Access Compliance Report Public Rights-of-Way (Curb Ramps)

Main Street: WIMBLETON_DR Cross Street: SHAKESPEARE_DR Location: SE

ADA ID: RPRK211215140504 Ramp Type: Type 1 - Perpendicular Diagonal Initial Pass/Fail: Pass Overall Compliance: No Severity Score: 14

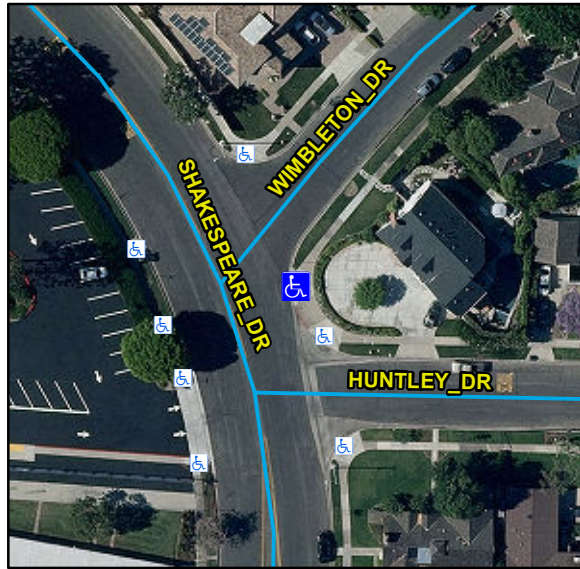
Remove & Replace Curb Ramp With Two New Directional Ramps or Equivalent. Gutter Ponding Observed.

R204.3, R304.2.1, R305, R302.7, STD 1115
